## CHRYSLER A604 (41TE) UPDATE HANDBOOK

### "UPDATE HANDBOOK"

Since the introduction of the Chrysler A604 (41TE) transaxle in model year 1989, there have been many engineering changes to greatly improve pleaseability, durability and driveability concerns. These changes have affected nearly every part used in the A604 (41TE) transaxle. This "Update Handbook" will explain each change, the reason for the change, any interchangeability concerns created by the change and any part numbers necessary to "Update" your unit. This booklet has been designed to be used in conjunction with the assembly and disassembly manual, also available from ATSG.

Figure 1

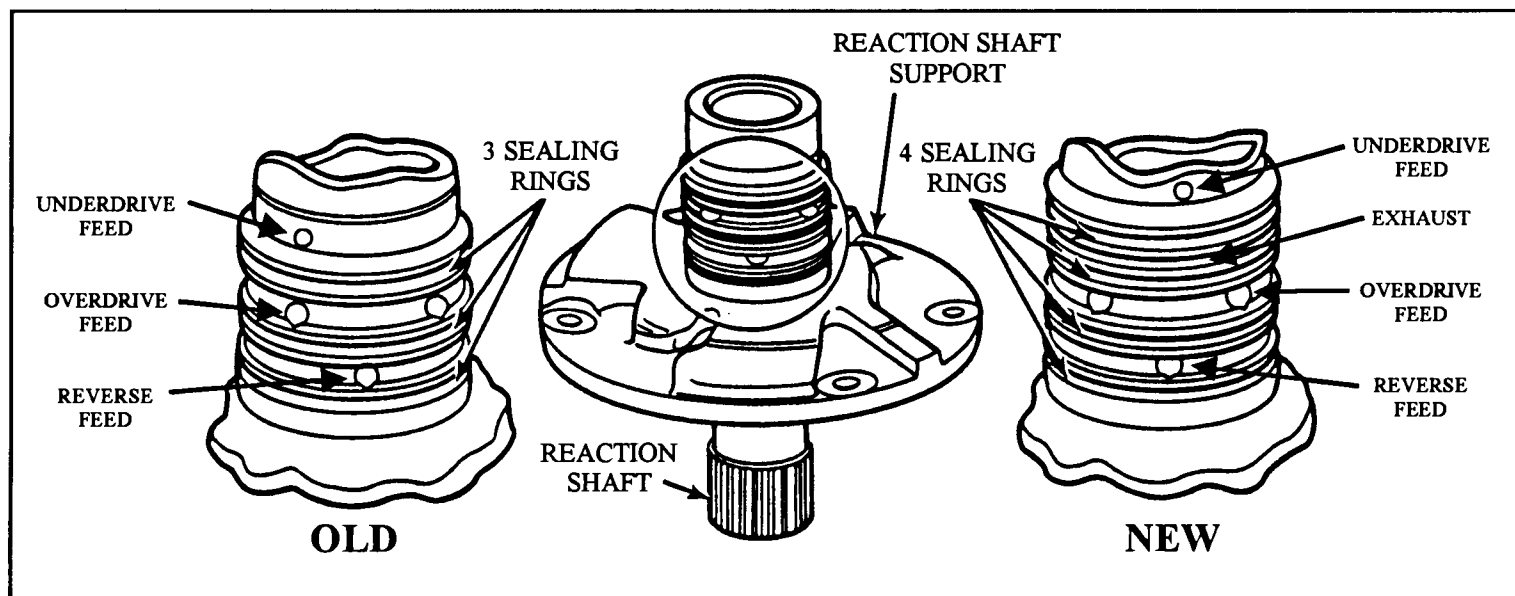
**CHANGE:** Beginning in April, 1989 a new Reaction Shaft Support (Stator) was introduced, with the addition of another ring groove and sealing ring. The old support has 3 sealing rings, and the new support has 4 sealing rings (See Figure 1).

- (1) **REACTION SHAFT SUPPORT** - The new support is longer, and has 4 sealing rings, where the old support only has three (See Figure 1).
- (2) **INPUT SHAFT/CLUTCH HUB** - The new Input Clutch Hub bore is machined deeper to accommodate the additional length of the reaction shaft, created by the added sealing ring (See Figure 2). The "O" Ring grooves are also cut shallower than the old input clutch hub, which increases the groove diameter, and provides improved compression or "Crush", between the "O" rings and the input clutch retainer. (See Figure 3).

Figure 4

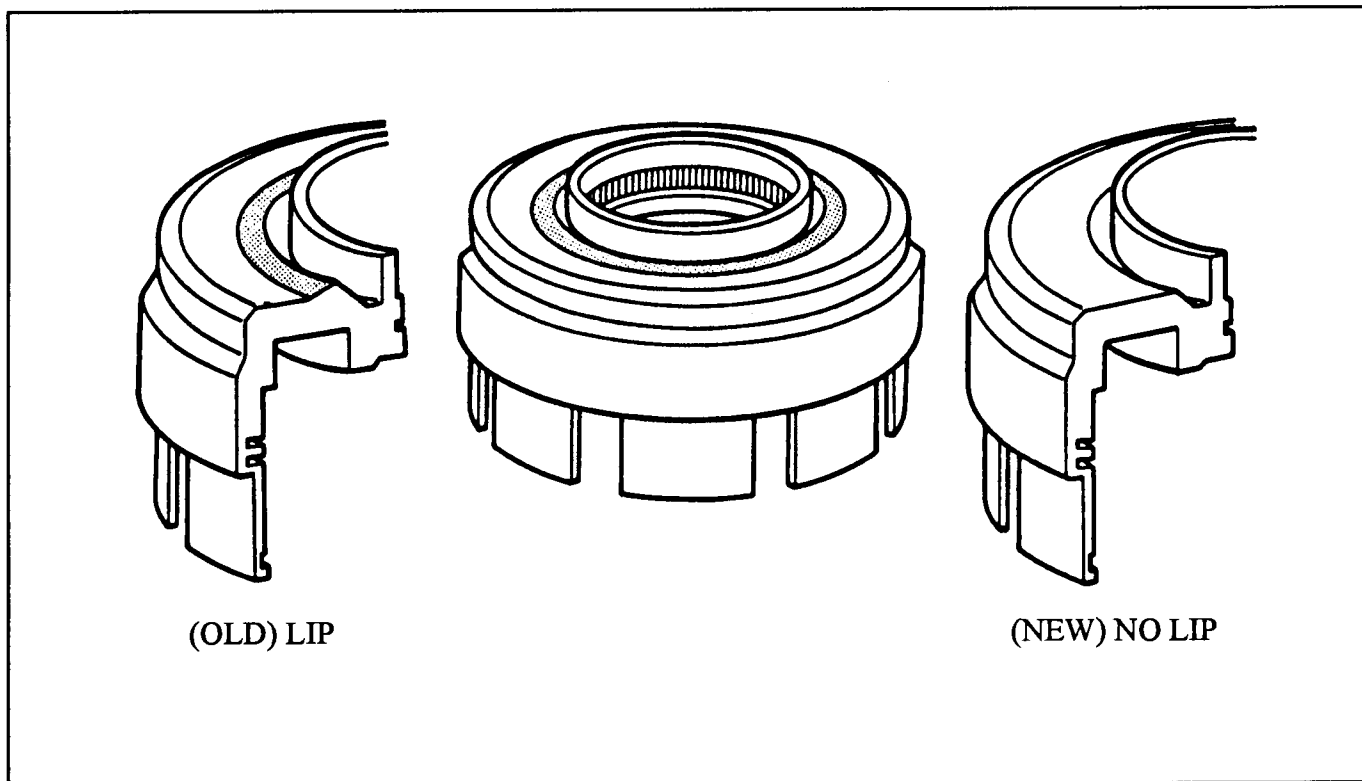
- (4) **INPUT CLUTCH RETAINER** - The Input Clutch Retainer was modified, by machining off the "Lip" (See Figure 4), to allow more travel of the overdrive/reverse piston. The old Input Clutch Retainer can be machined at the local machine shop if necessary.

Figure 5

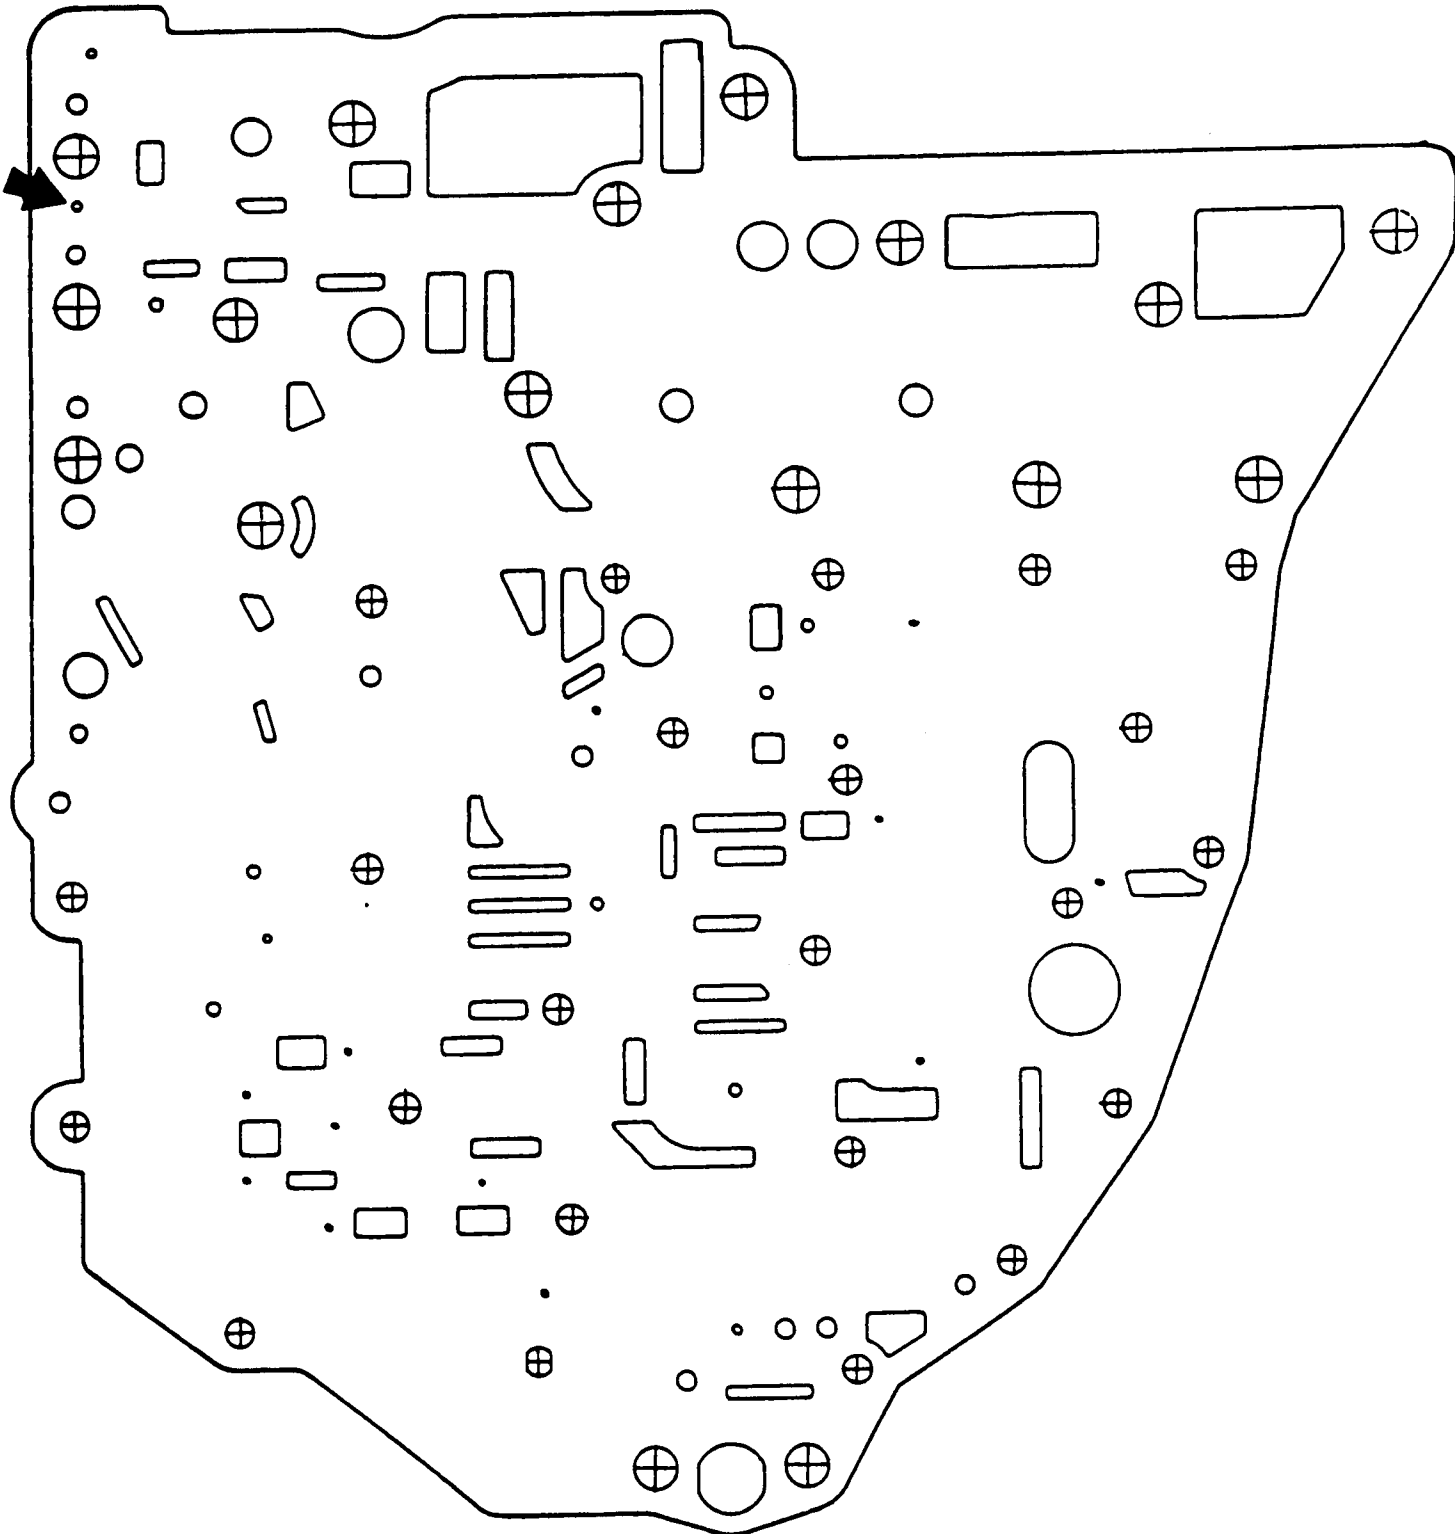
- (5) **SPACER PLATE** - The new Spacer Plate has a larger (.105") overdrive clutch feed orifice to provide increased oil flow to the overdrive clutch circuit (See Figure 5).

THE HOLE INDICATED BY THE ARROW BELOW HAS BEEN ENLARGED TO .105" FOR INCREASED OIL FLOW TO THE OVERDRIVE CLUTCH CIRCUIT.

Figure 6

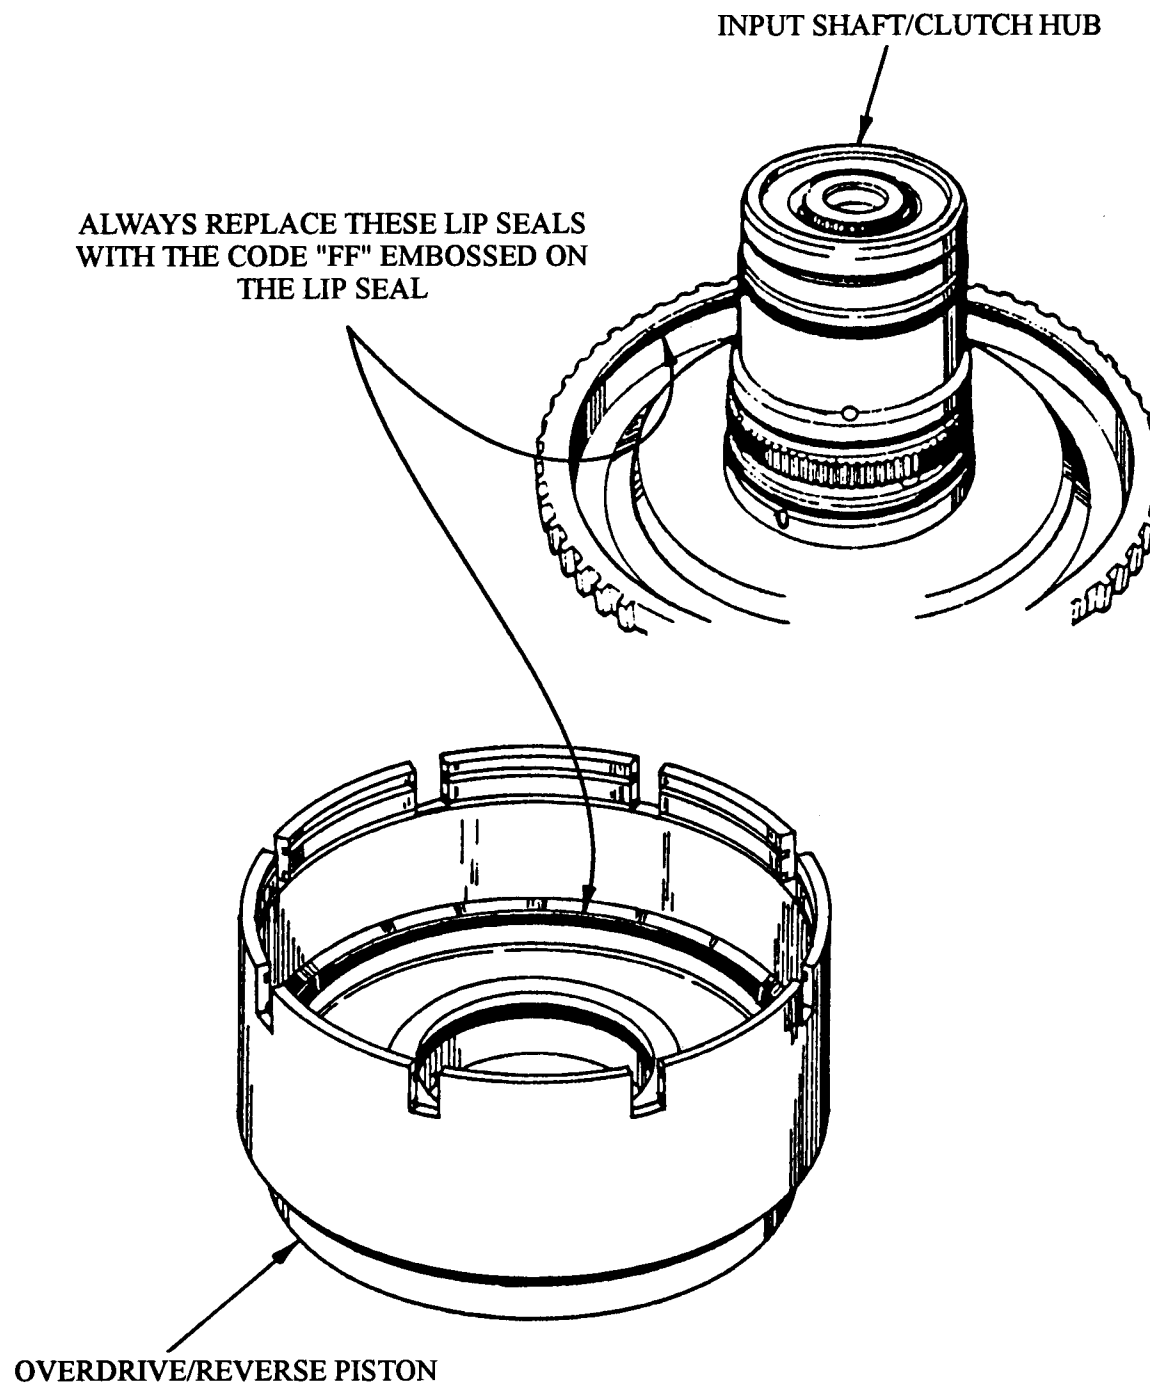
**CHANGE:** The lip seals in the Overdrive/Reverse Clutch Piston and the Input Shaft/Clutch Hub are now replaced with lip seals made of different material (See Figure 6).

- (1) OD/REVERSE PISTON LIP SEAL - No dimensional changes, but the material changes, and the new lip seals can be identified by the code "FF" embossed into the seal. The old lip seal is embossed with the code "IPC", and should not be used (See Figure 6).
- (2) INPUT CLUTCH HUB OUTER LIP SEAL - No dimensional changes, but the material changes, and the new lip seals can be identified by the code "FF" embossed into the seal. The old lip seal is embossed with the code "IPC", and should not be used (See Figure 6).

**THE NEW LIP SEALS EMBOSSED WITH THE CODE "FF" WILL RETROFIT BACK TO ALL PREVIOUS MODELS, AND SHOULD BE USED DURING OVERHAUL.**

Figure 8

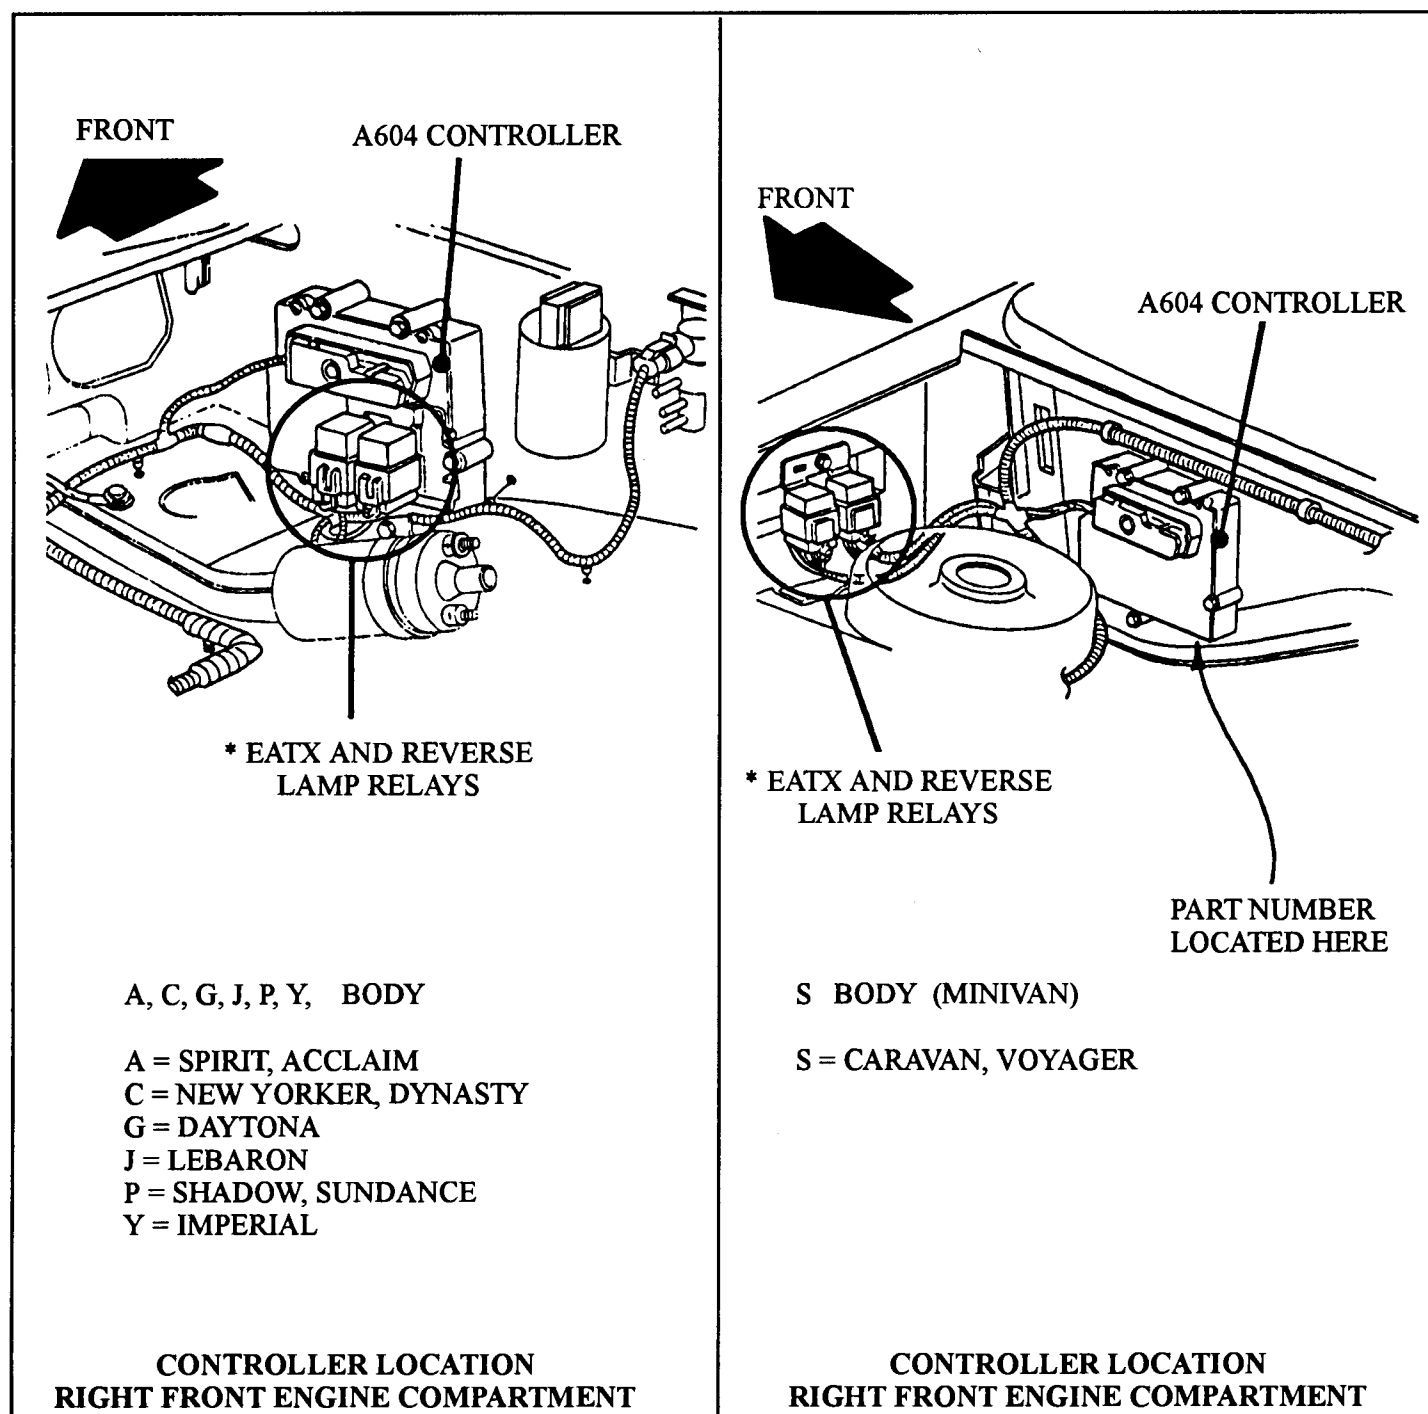
- (1) **TRANSAXLE CONTROLLER** - Controllers can be identified by the OEM part number that is printed on a sticker. This sticker can be located on the bottom of the transaxle controller as shown in figure 8. If the sticker is missing, scanners will also provide controller identification by providing the OEM part number of the controller that is in the vehicle. Refer to the chart on the following page for a brief overview of past controllers.  
The locations of the controllers will vary depending on the model of the vehicle. Refer to figure 8 for the different locations. Figures 8 and 9 also shows the locations of the EATX relay, as their location will vary depending on the model of the vehicle.

Figure 14

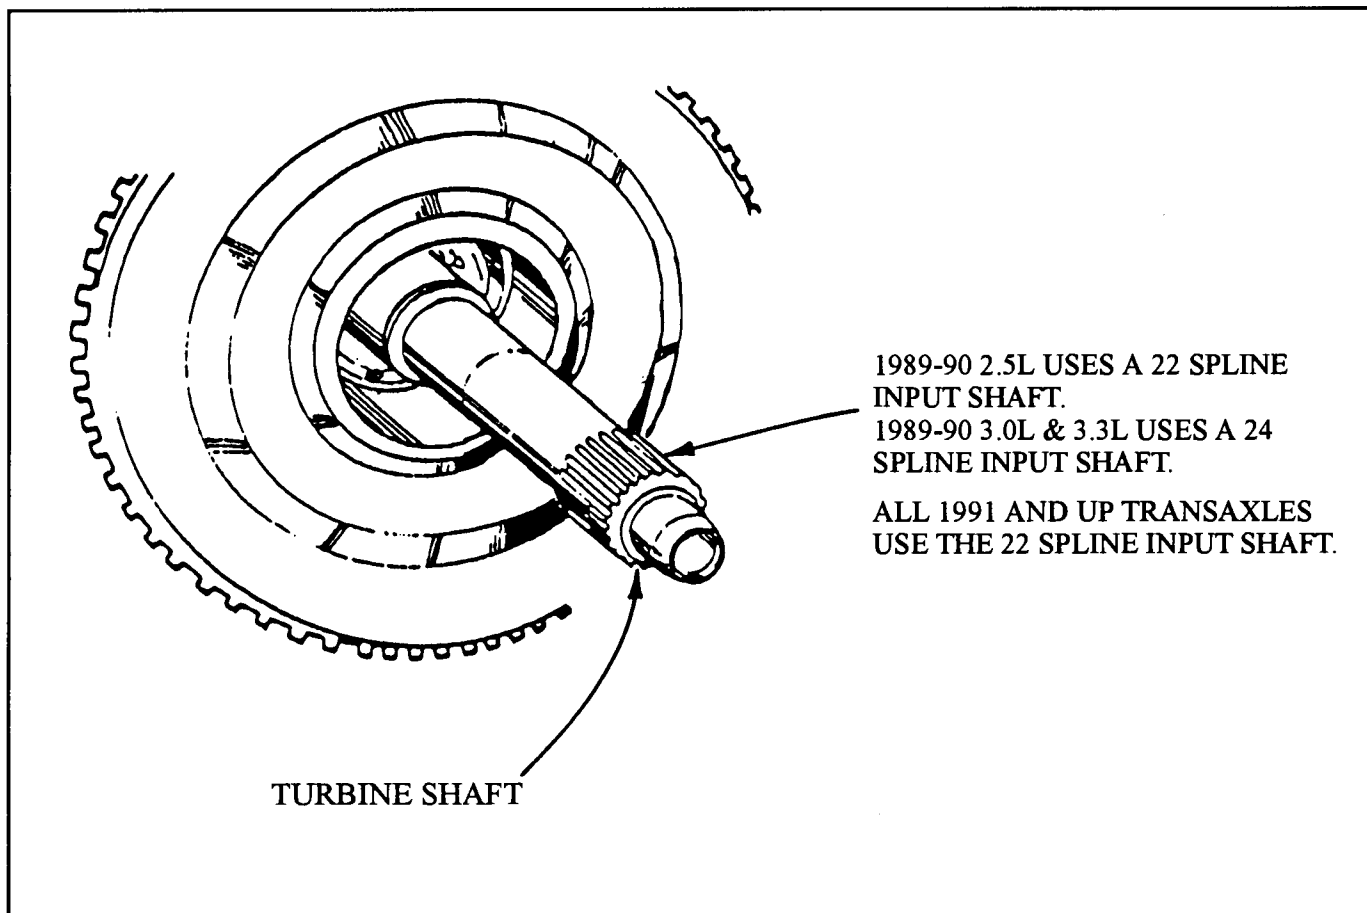
- (2) **TURBINE SHAFT SPLINES** - 1989-1990 2.5 Litre engine uses a turbine shaft with 22 splines for the torque converter, and the 1989-1990 3.0 and 3.3 Litre engines will use the a 24 spline turbine shaft (See Figure 14).

**NOTE:** All 1991 and up A604 transaxles will use a 22 spline input shaft to fit a new torque converter with a torsional vibration damper (See Figure 14).
